Request	-	Special Use Permit for used auto sales
Location	-	3125 Dorr Street
Applicant & Owner	-	Joe Saadeh Whiteford of Ohio LLC 4621 Plumbrook Drive Toledo, OH 43623
Engineer	-	Architecture by Design 5622 Mayberry Square Sylvania, OH 43560

SPECIAL USE PERMIT
TOLEDO CITY PLAN COMMISSION
REF: SUP-5005-23
DATE: August 10, 2023
TIME: 2:00 P.M.

SUP-5005-23

SUP-5005-23

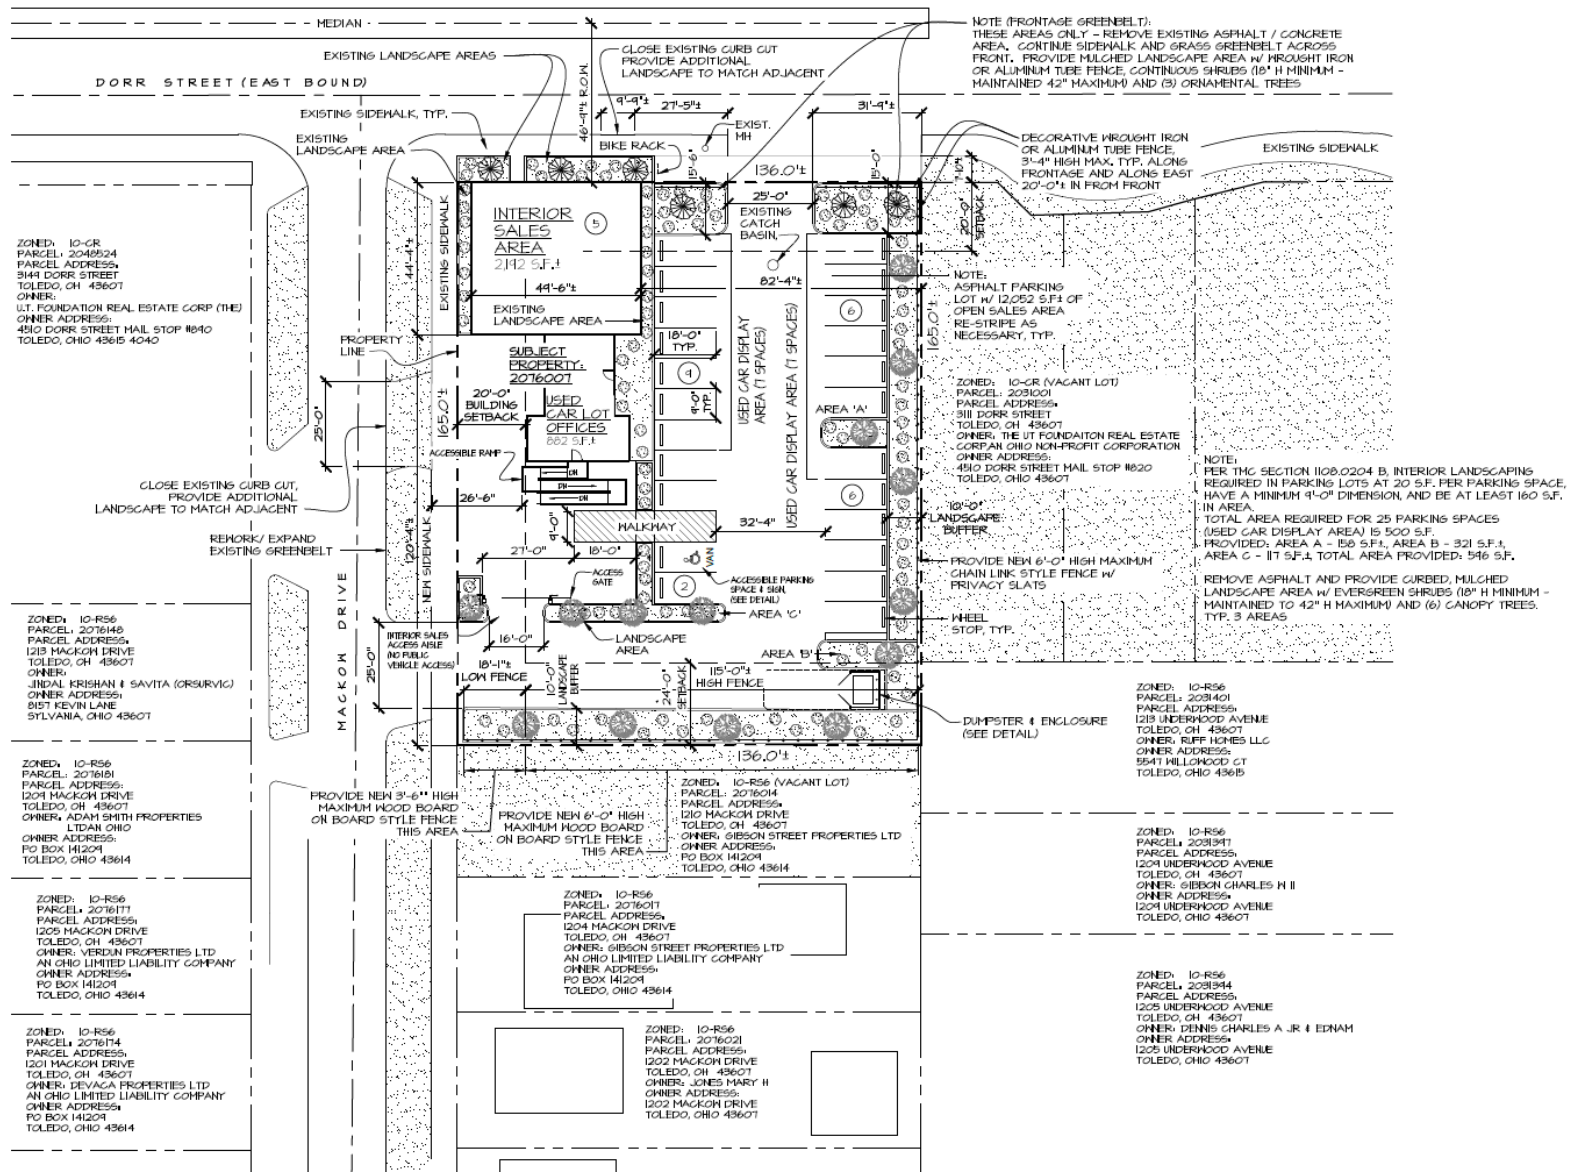
The site plan depicts nine (9) spaces for customer/employee parking and meets the total requirement. In addition to the required parking spaces, one (1) van accessible space is required per **TMC§1107.1700**. An accessible space with an eight foot (8') abutting aisle is provided, and meets the requirement. Lastly, bicycle parking is not required for auto sales, however it is required for offices. Two (2) bicycle parking spaces are required and are shown on the site plan.

Used auto sales require fencing around customer display areas, and screening for any outdoor storage (**TMC§1104.0305**). The site plan depicts a decorative metal fence along Dorr Street and twenty feet (20') from Dorr Street going south along the east property line. A chain link fence with privacy slats is proposed from where the decorative fence ends to the southern property line. Per **TMC§1108.0404(B)**, chain link cannot be used to meet buffer and screening requirements. A revised plan depicting an acceptable material shall be provided.

Frontage greenbelts as outlined in **TMC§1108.0202** are required along Dorr Street and along Mackow Drive. Six (6) trees along Dorr Street are provided, which meet the requirement of one (1) tree per thirty feet (30') of frontage. No trees are proposed along Mackow Drive. A minimum of four (4) trees shall be provided in the tree lawn as there are existing street trees lining Mackow Drive. Applicant shall contact the Division of Forestry to request the street trees and a revised site plan shall be provided.

As the CR-Regional Commercial site abuts RS6-Single Family Residential to the south, a Type A landscape buffer shall be installed along the eastern property line per **TMC§1108.0203**. The site plan depicted a new board-on-board fence that is 3'6" tall in the front setback and 6' tall along the rest of the property. Four (4) trees and fifteen (15) shrubs are shown abutting the fence. As the site is 136' in width, one (1) additional tree and six (6) shrubs are required in order to meet the Type A Landscaping requirement.

Well maintained parking lot landscaping is tremendously important for auto sales businesses with outdoor display areas. **TMC§1108.0204** outlines the requirements for both interior and perimeter parking lot landscaping. The interior of the parking lot requires two (2) trees and six (6) shrubs per each ten (10) parking spaces. The total number of parking spaces, including the display area, is twenty-three (23), requiring five (5) trees and fourteen (14) shrubs. Six (6) trees and eleven (11) shrubs are provided. Per **TMC§1108.0204(C)(1)(b)**, One (1) canopy tree may substitute for three (3) shrubs. The applicant is proposing summer red maples, and therefore the site plan meets the interior requirements. Perimeter landscaping requires a continuous shrub row and one (1) tree per thirty linear feet (30'). The east side of the parking lot has a shrub row with five (5) trees and is compliant. The west side however has a shrub row with no trees. A revised site plan with at least three (3) trees on the west side of the parking lot shall be provided.

5. A site plan error is noted. The existing storm drain on the site plan does not exist.
6. It is unclear from the Plan Commission submittal if the proposed work will entail earth-disturbing activity of 2,500 or more square feet, or if there will be any changes to the existing storm sewer system. If revisions are made to the site plan that will result in earth-disturbing activity of 2,500 or more square feet or cause changes to the existing storm sewer, a full site plan review and approval will be required by the Division of Engineering Services. Plans will be subject to the rules and regulations of the City of Toledo, Stormwater Utility, including stormwater detention and post-construction stormwater BMPs as specified in the City of Toledo Infrastructure Design and Construction Requirements and the Ohio EPA NPDES General Stormwater Permit for Construction Activities.

- a. Used auto sales require decorative fencing around display areas. A chain link fence is proposed. **Not acceptable as depicted, per TMC§1108.0404(B), chain link cannot be used to meet buffer and screening requirements. Revised plan with an appropriate fence material shall be provided.**

- b. A fifteen-foot (15’) frontage greenbelt is required along Dorr Street and Mackow Drive frontages, and shall include one (1) tree per every thirty feet (30’) of frontage; **not acceptable as depicted, revised site plan with at least four (4) street trees along Mackow Drive shall be provided.**

- c. A Type A Landscape buffer shall be installed on the southern side of the property per where the site abuts RS6-Single Family Residential Zoning. Four (4) trees and fifteen (15) shrubs are shown abutting the fence. **Not acceptable as depicted. As the site is 136’ in width, one (1) additional tree and six (6) shrubs are required in order to meet the Type A Landscaping requirement.**

- d. Perimeter landscaping shall be installed along any parking lot area adjacent to a street, place, or driveway and shall be provided abutting the parking area to visually screen all off-street loading facilities from view of public right-of-ways. A minimum of at least one canopy tree must be provided for each 30 linear feet, plus a continuous shrub with a minimum height of 18 inches. **Not acceptable as depicted. A revised site plan with at least three (3) trees on the west side of the parking lot shall be provided.**
